Subject: RATTLE NOISE FROM REAR OF VEHICLE WHILE DRIVING	Bulletin No.: 02-016/18
	Last Issued: 09/27/2018

2013-2016 CX-5

TYPE B (Nut)
TYPE A (Bolt)

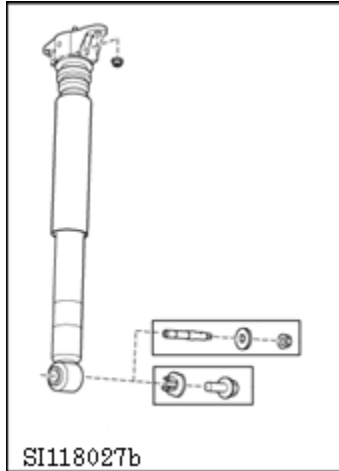
Due to insufficient durability of the bracket in certain environments, such as where road salt is used, corrosion and breakage can occur. To eliminate this concern, the material and the shape of the bracket (service parts) has been modified.

1. Verify the customer concern.
2. Replace the affected rear shock absorber assembly with a modified service part according to the instructions on MGSS online (REAR SHOCK ABSORBER ASSEMBLY REMOVAL/INSTALLATION).
3. Verify the repair.
